**Re: Christina Lake Thermal Project Phase H and Eastern Expansion
Project Update and Supplemental Information Request 2 Responses
AER Application No. 1758947
EPEA Application No. 019-48522**

The purpose of this document is to provide responses to the Round 2 SIR package and provide updated information regarding the Project (Project Update). This document is organized into two parts as follows:

I:\CLIENTS\CENOVUS\14-1346-0011\Mapping\MXD\C&R\SIR_Round2\ESRD_SIR_17_Figure_37_11.mxd

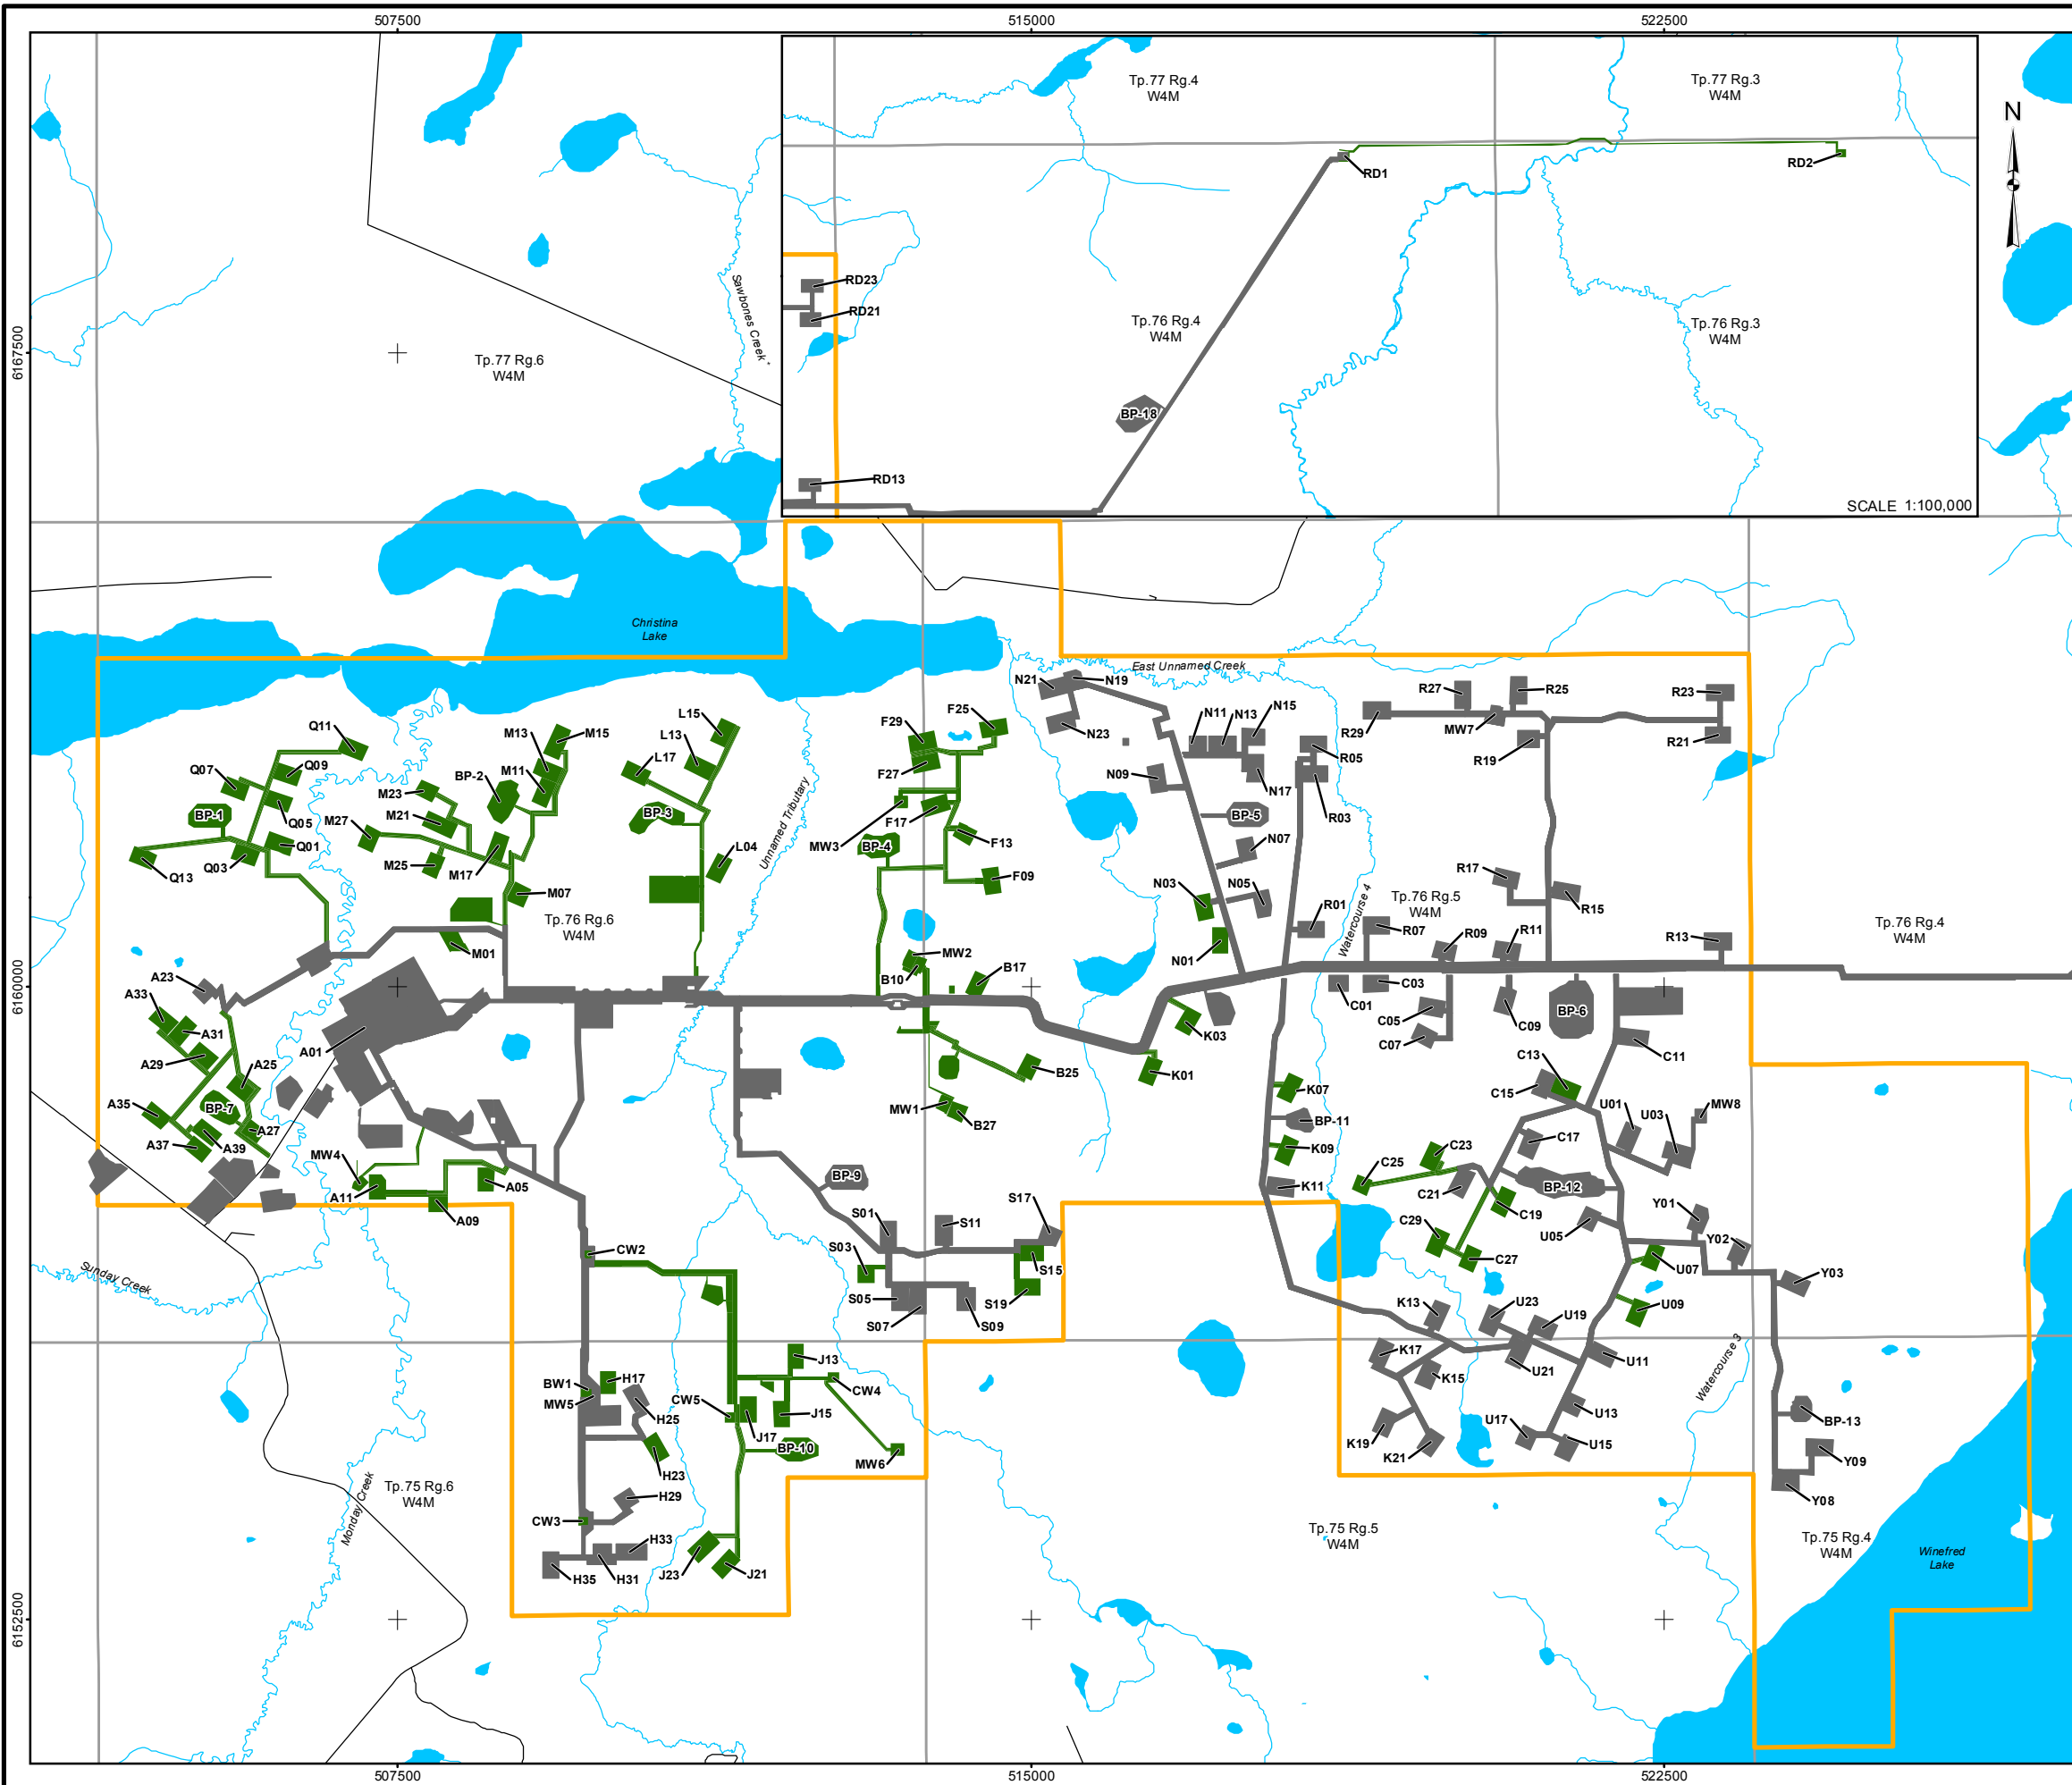
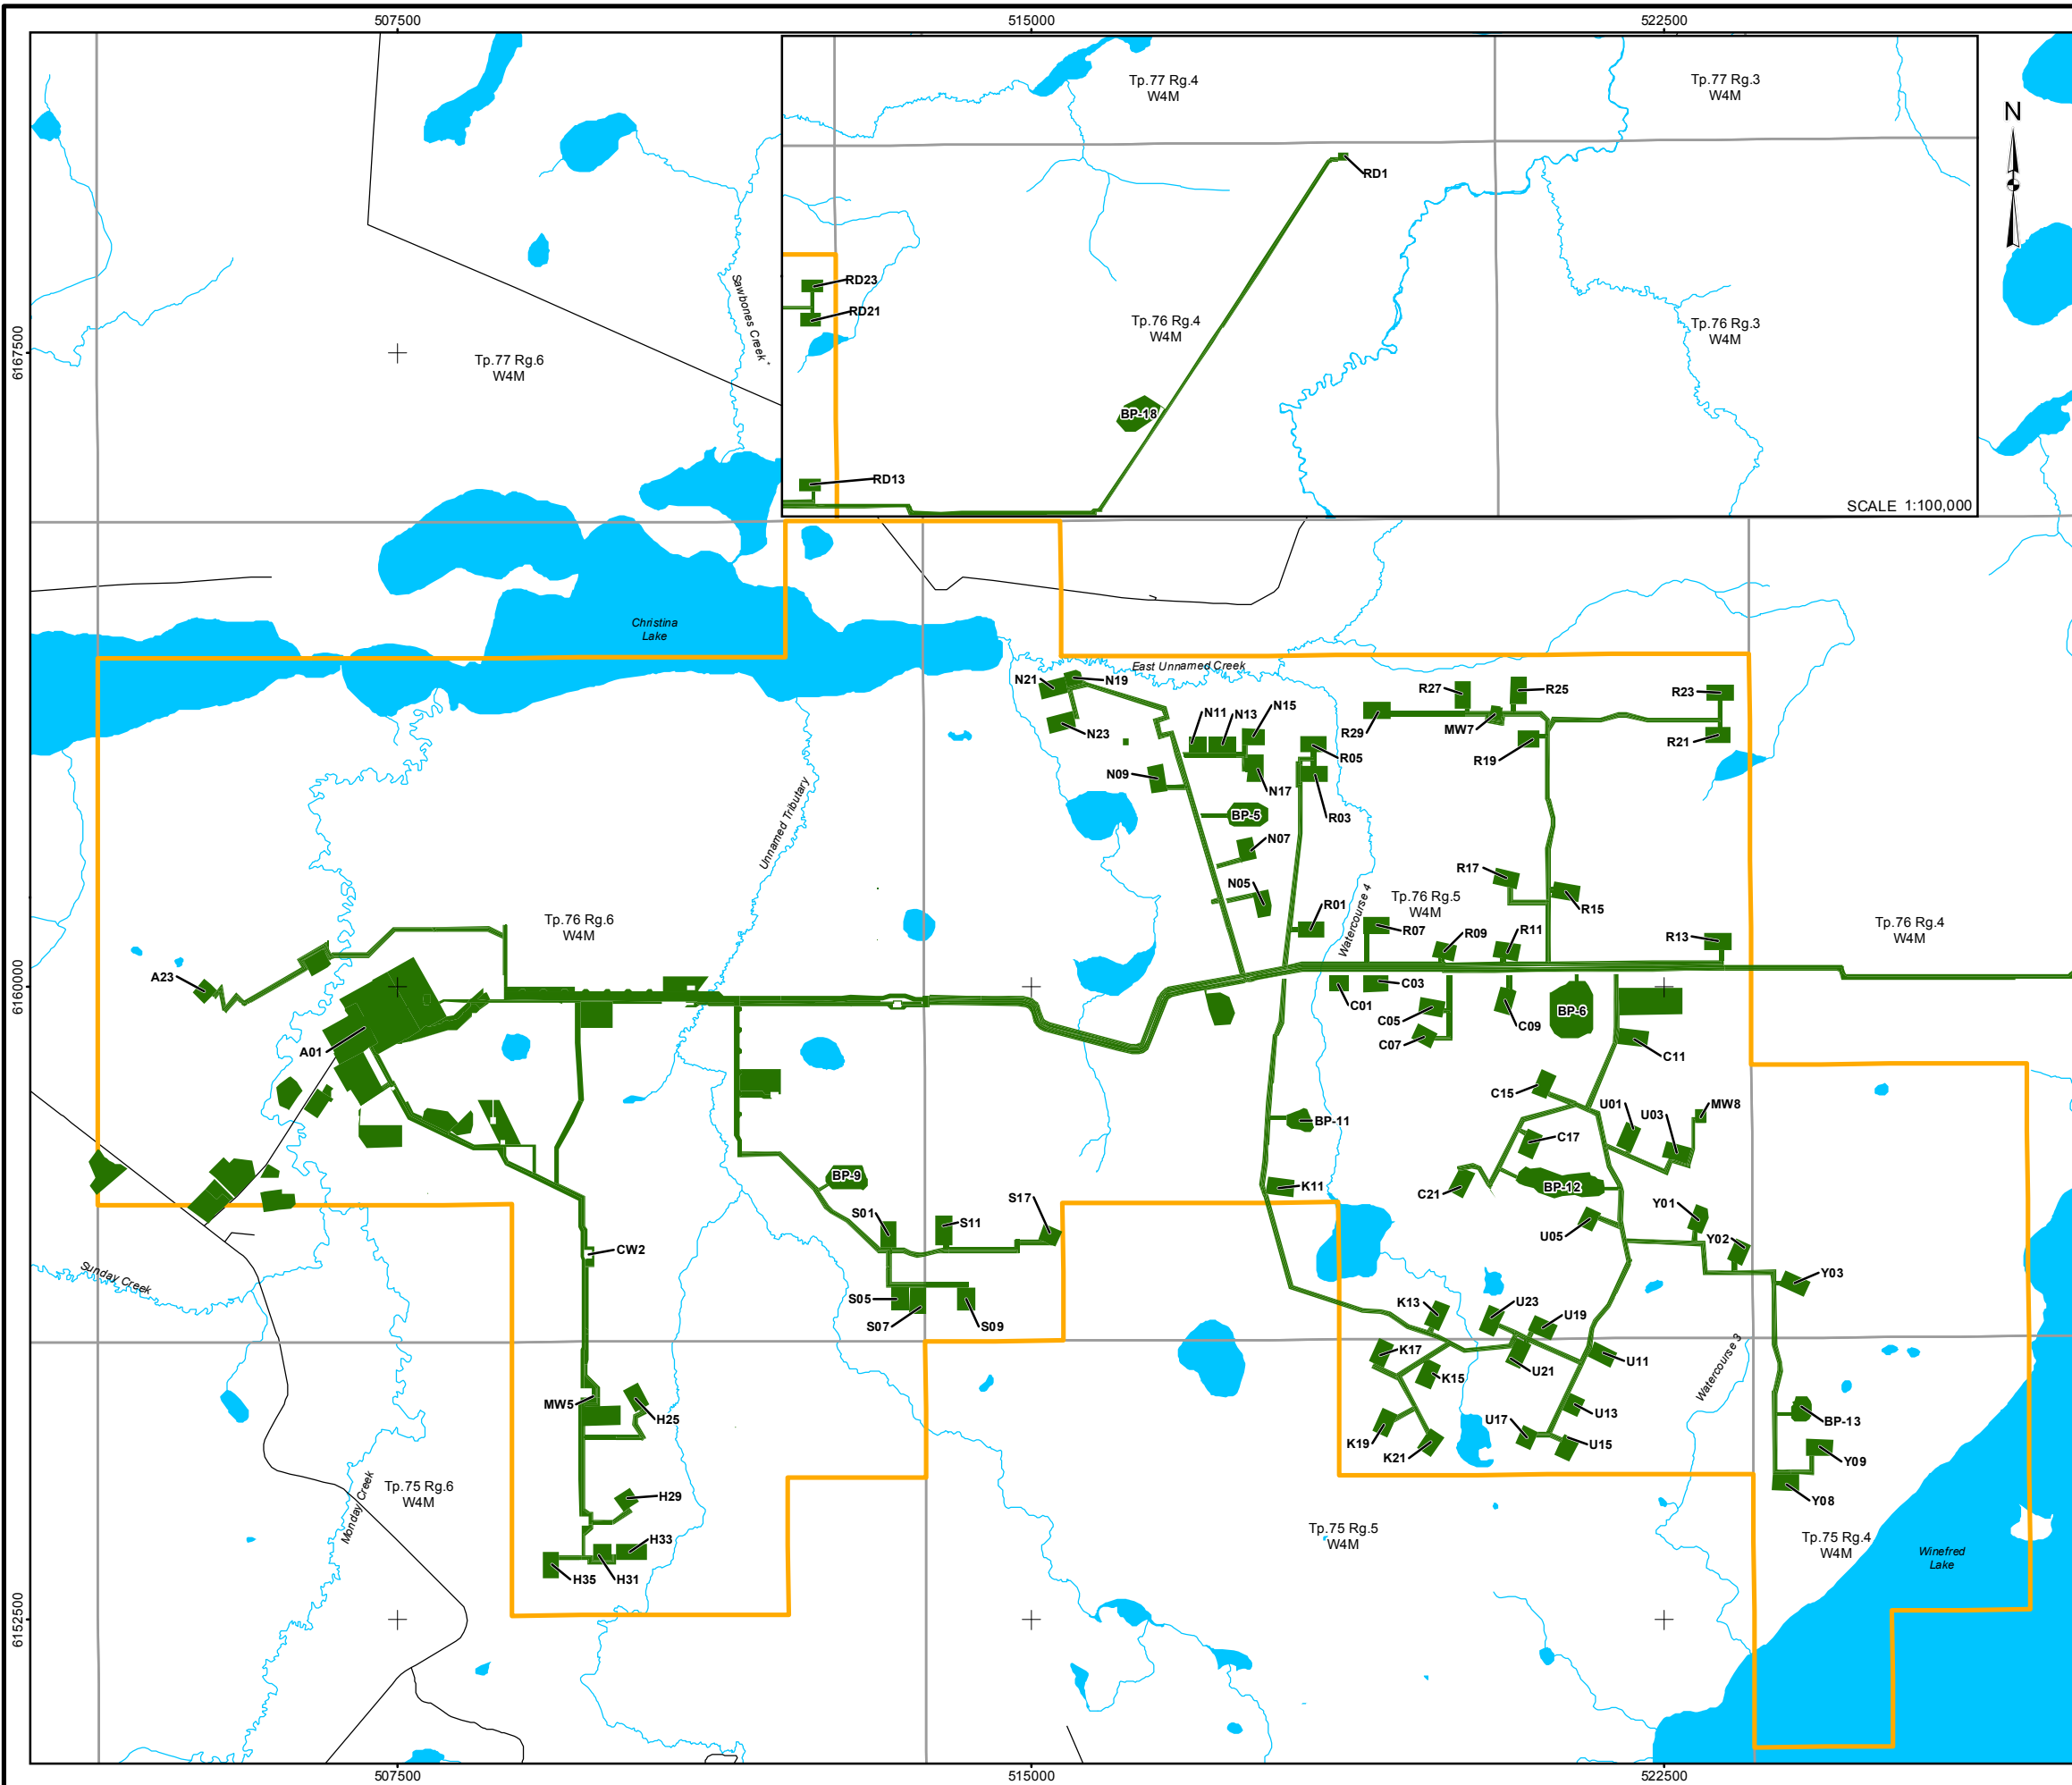
In Table 65-2, the column Unnamed (Monday) Creek appears to be mislabelled. All Figures in the SIR response 69 are mislabelled. In Figure 186-1, the sub-watershed is mislabelled.

Figures 69-1 to 69-13 from ESRD Round 1 SIR 69 have been revised and are presented as [Figures 37-1 to 37-13](#).
